# CITY PLAN COMMISSION STAFF REPORT

Chatham Ave Self Storage

## Plan Conditions, Corrections, & Suggestions Report

Case Number: CD-CPC-2024-00196

A-201

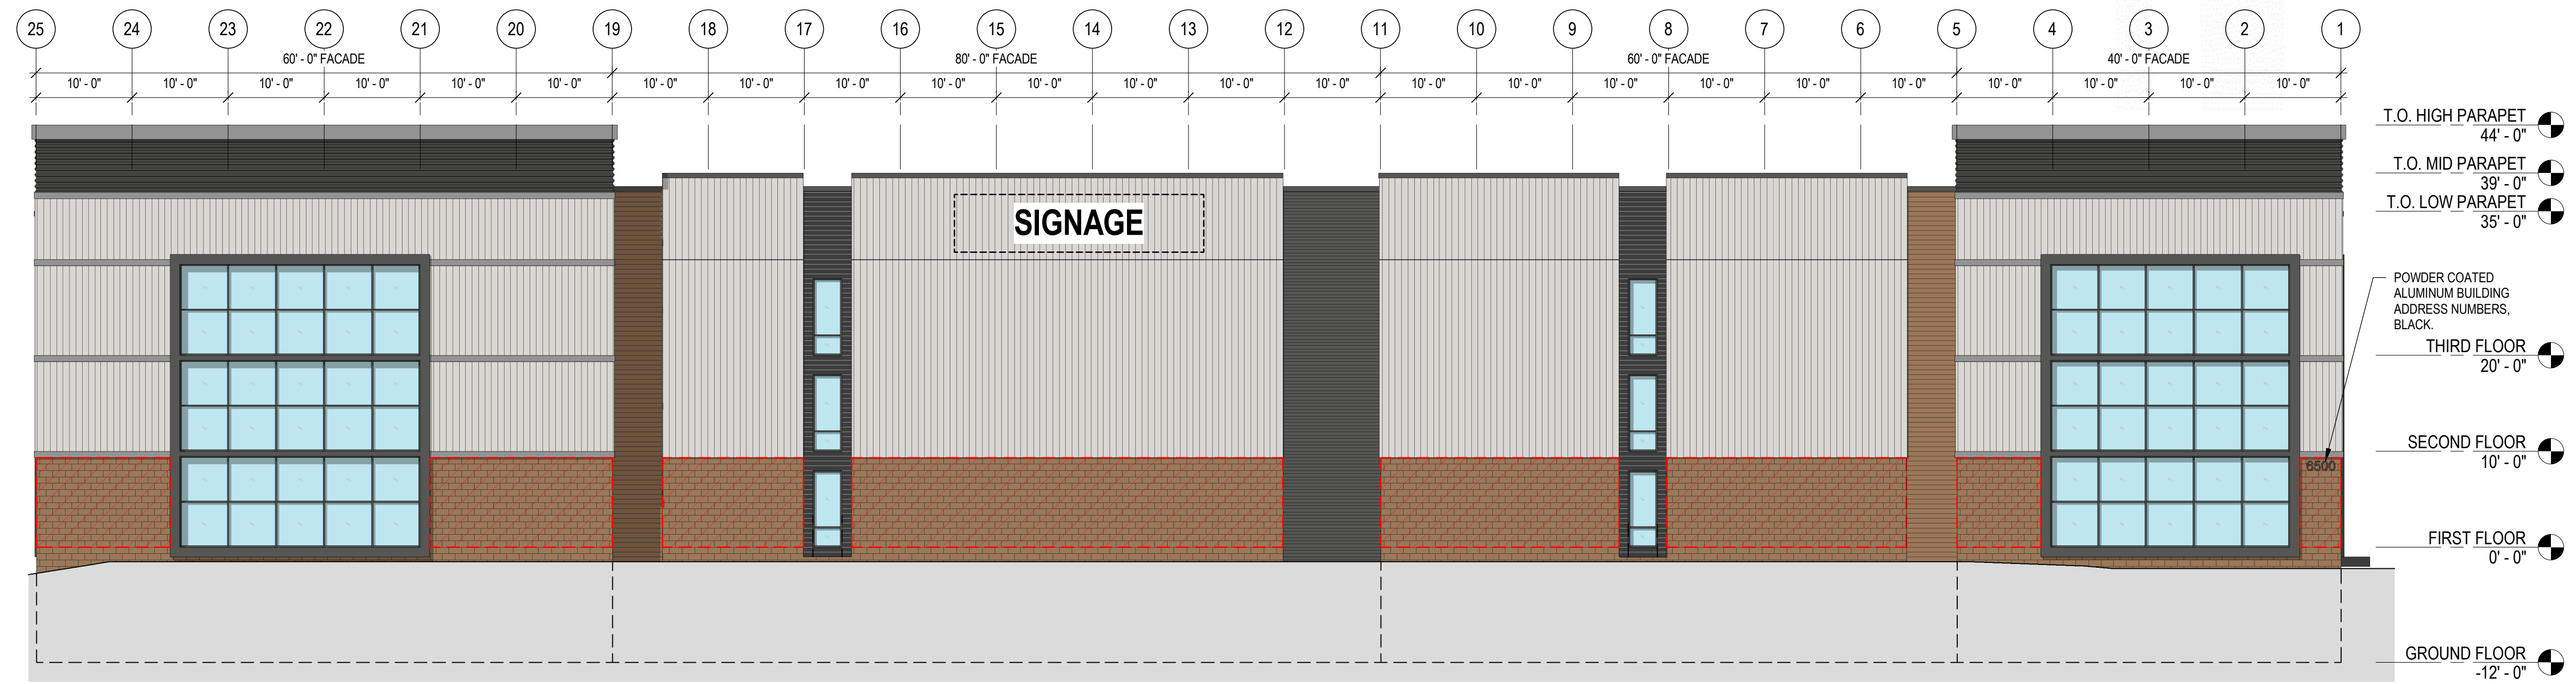
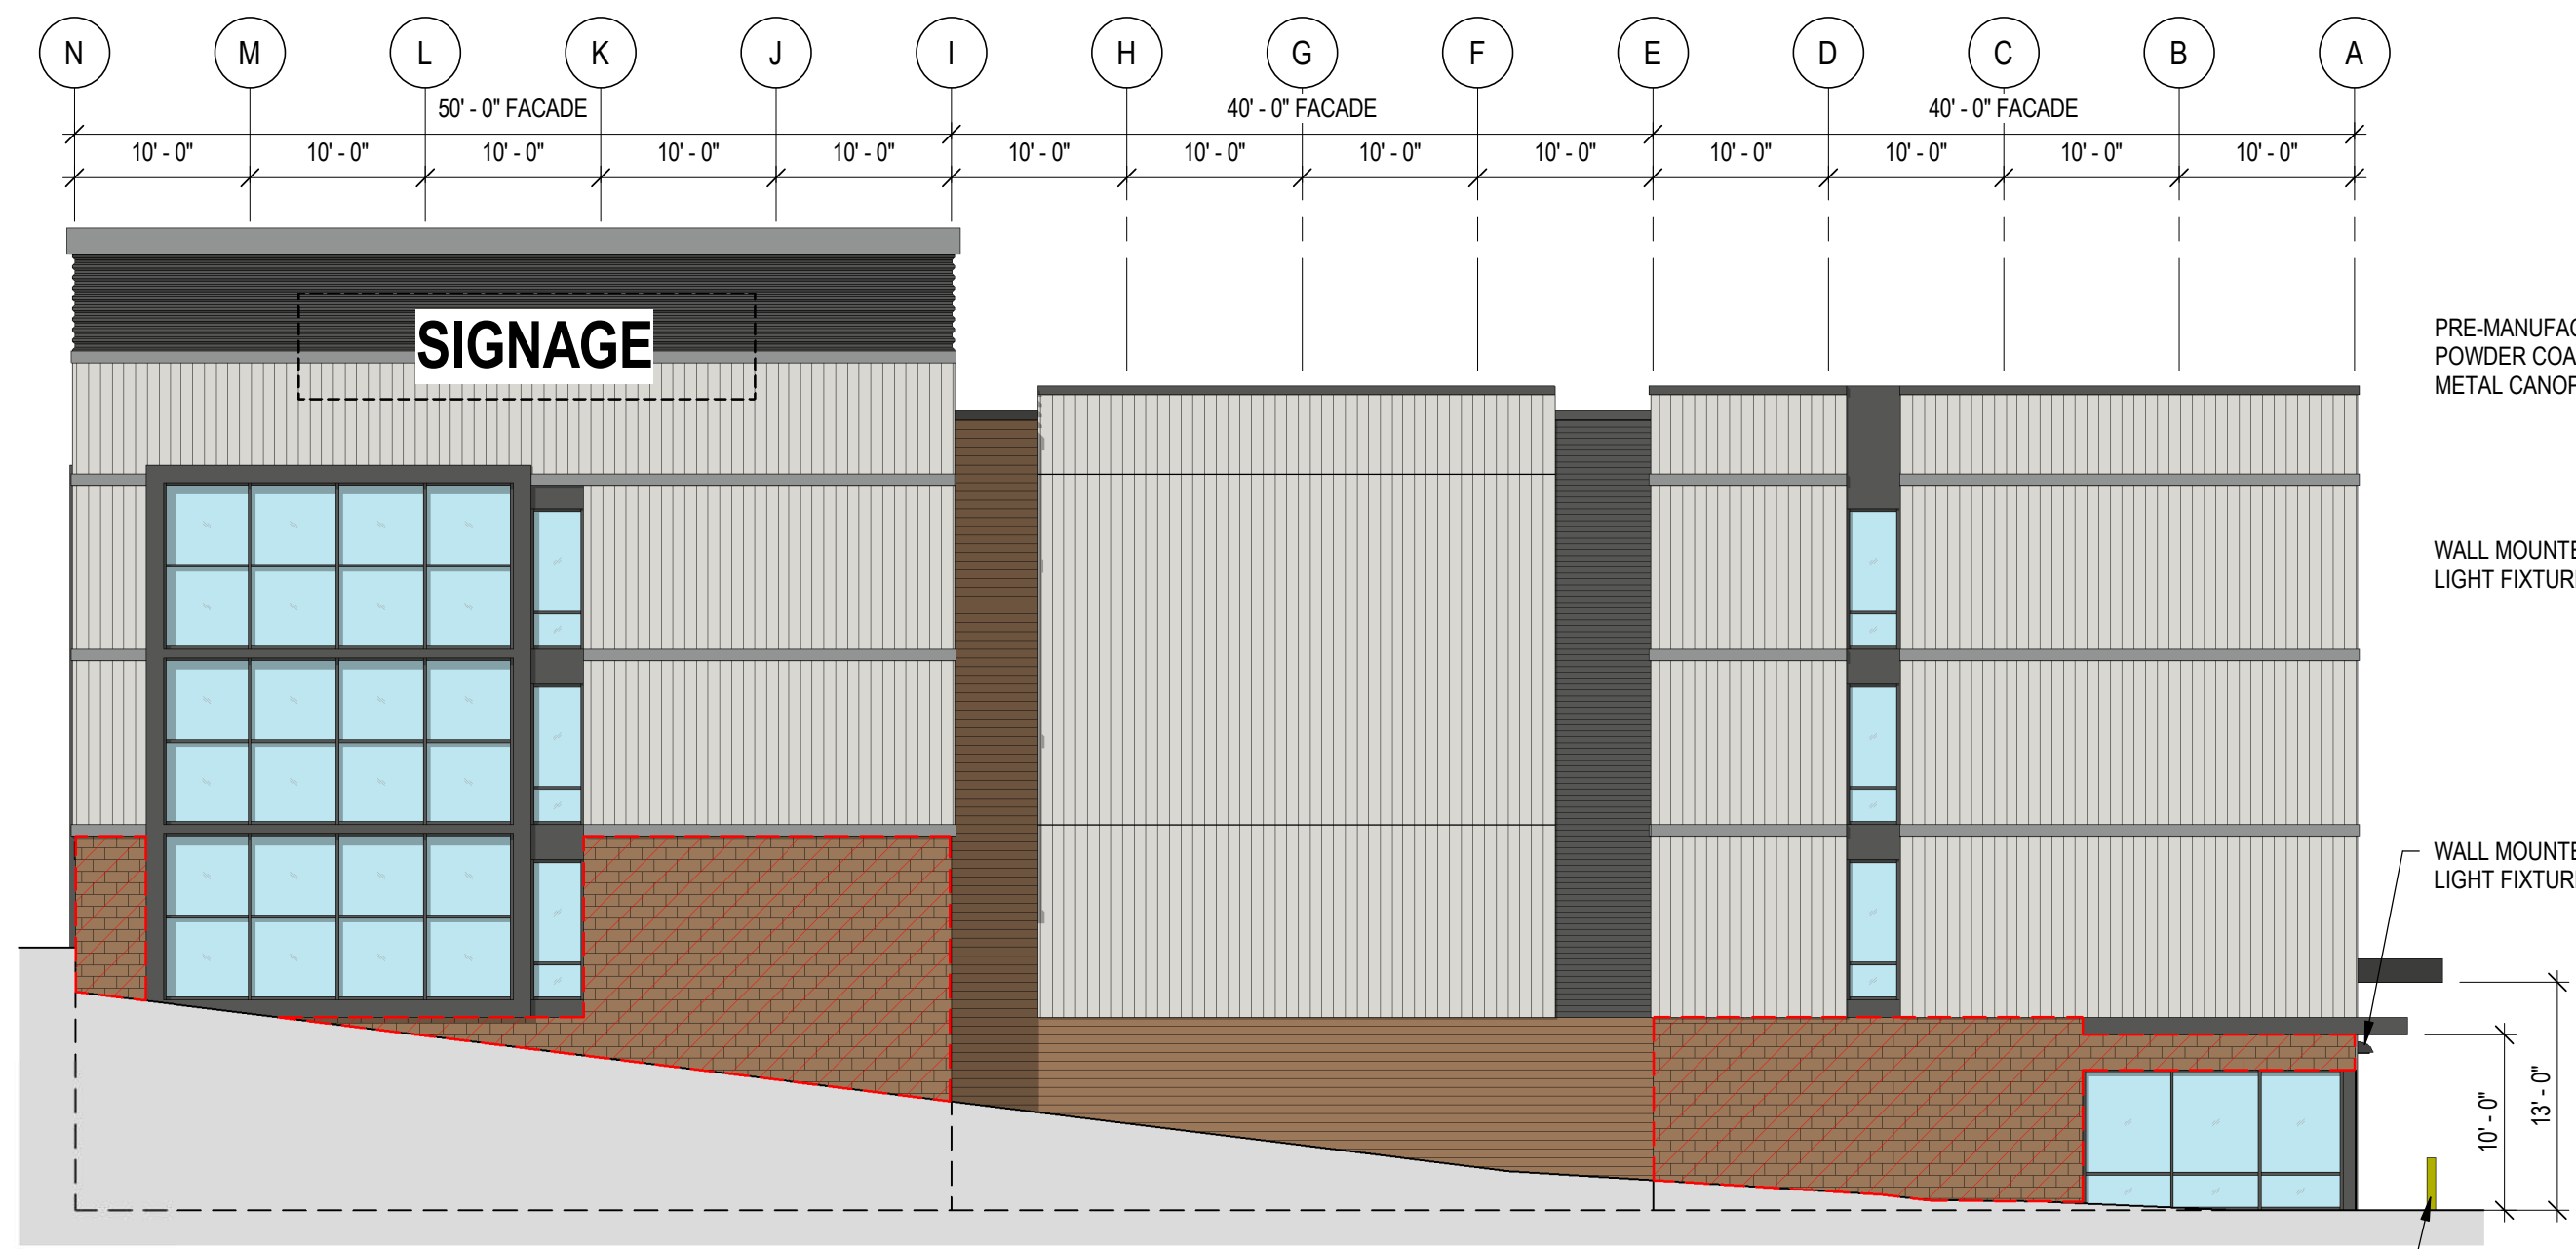
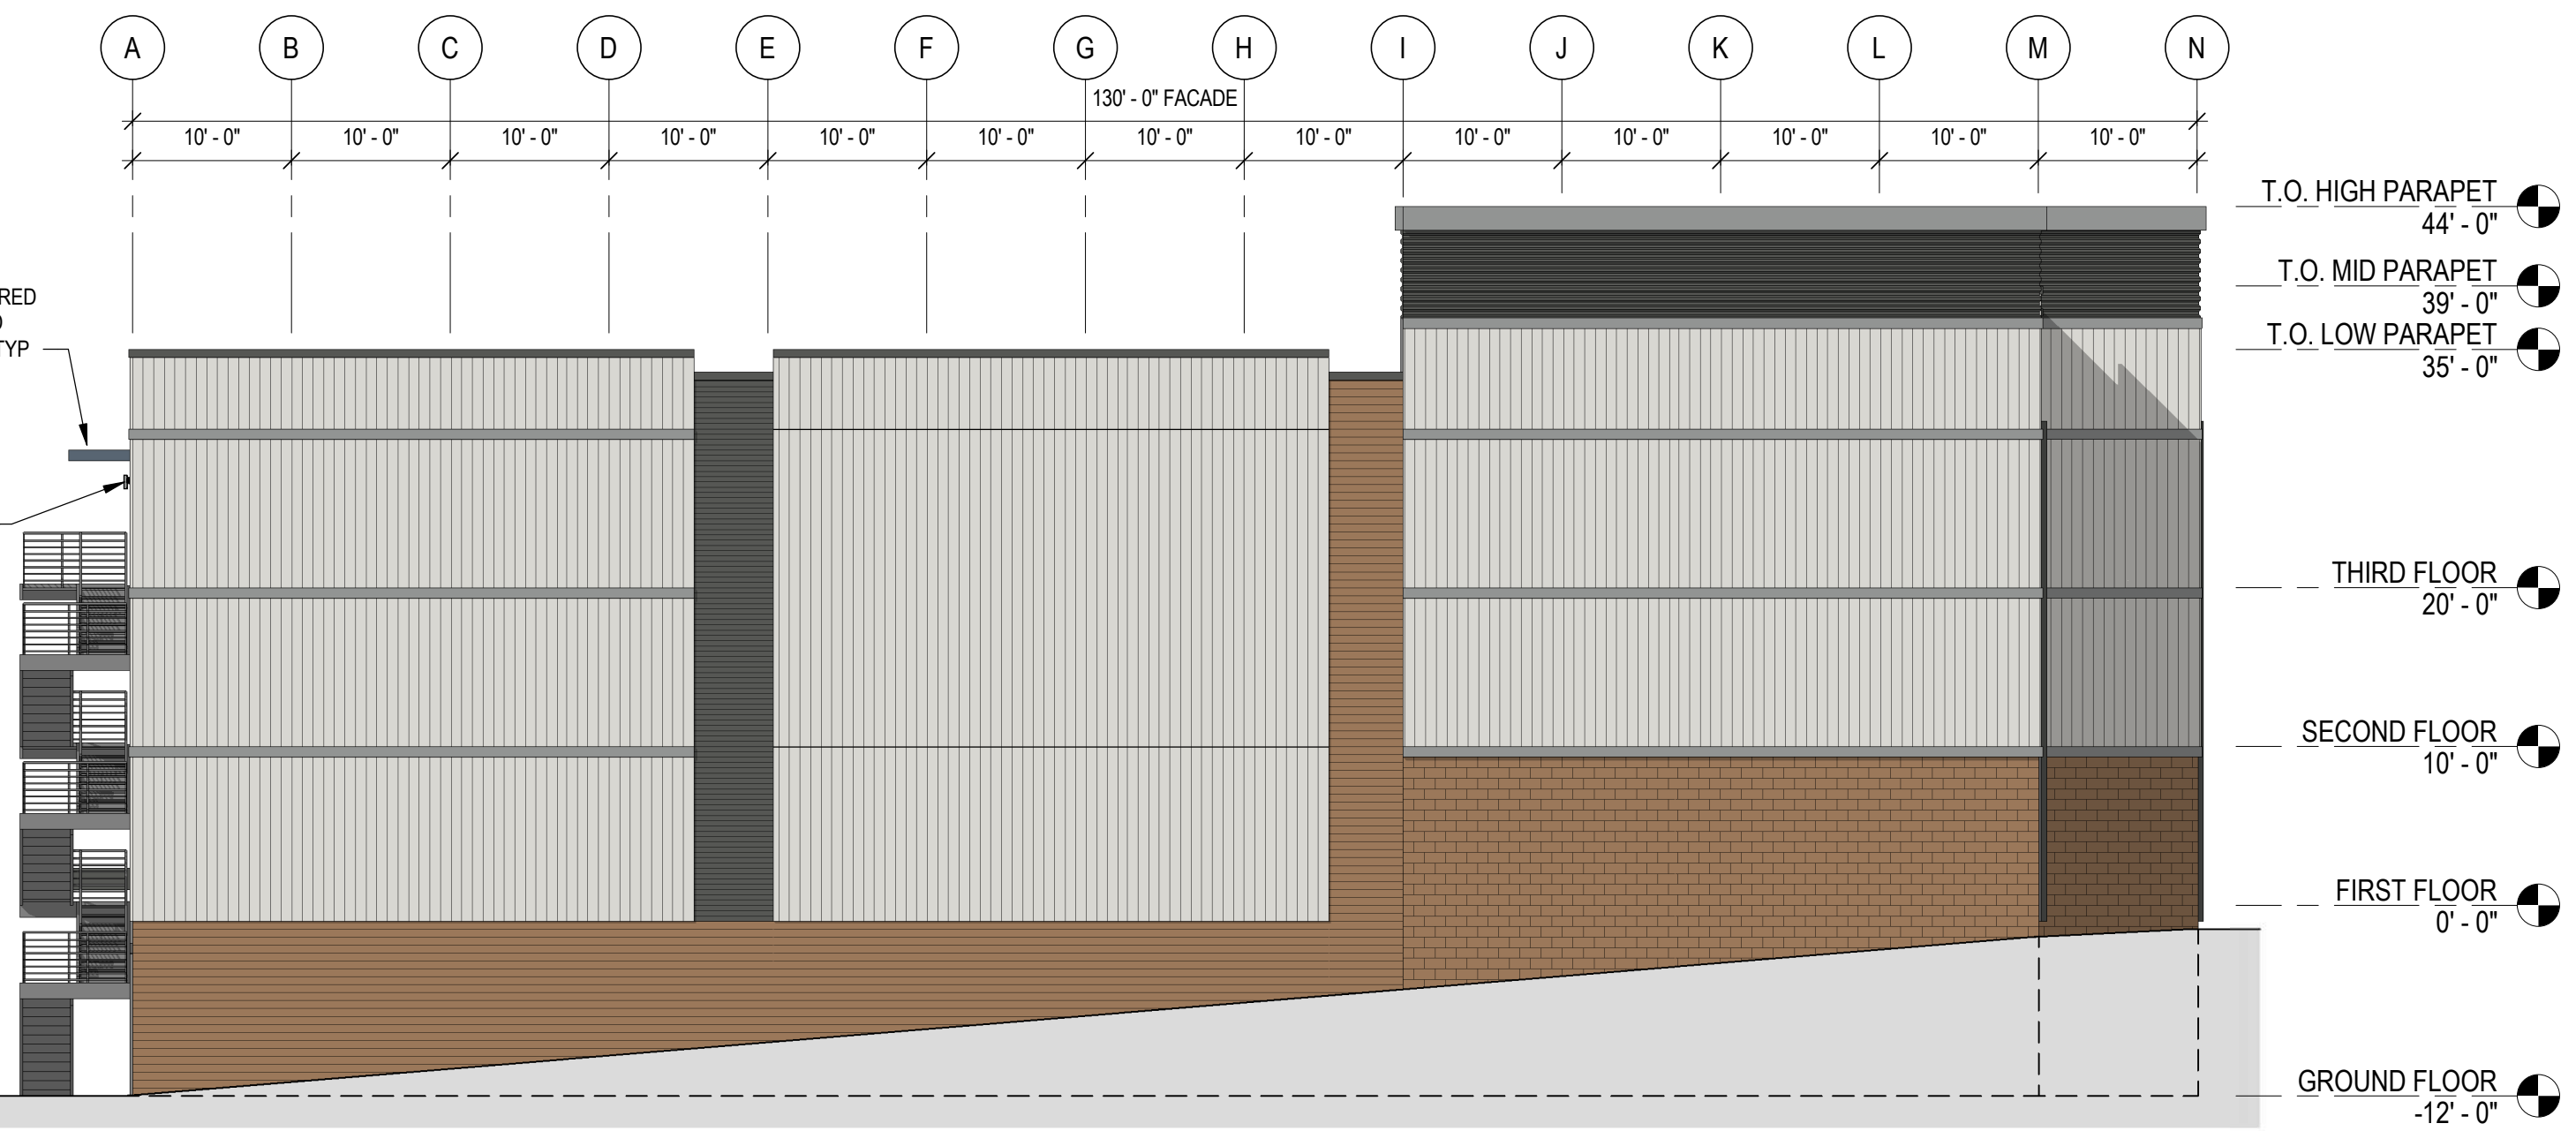
1. Per 88-369: Any wall abutting public right-of-way and over 75 feet in length shall include a combination of at least two of the following features: facade setbacks, change of building materials, varied roof line, a water table, or pilasters. Indicate which 2 features utilized on elevation sheets. UPDATE 1/23/25: Couldn't locate any notes identifying 2 of the above features on the plans as stated in the response letter. (1/21/2025)
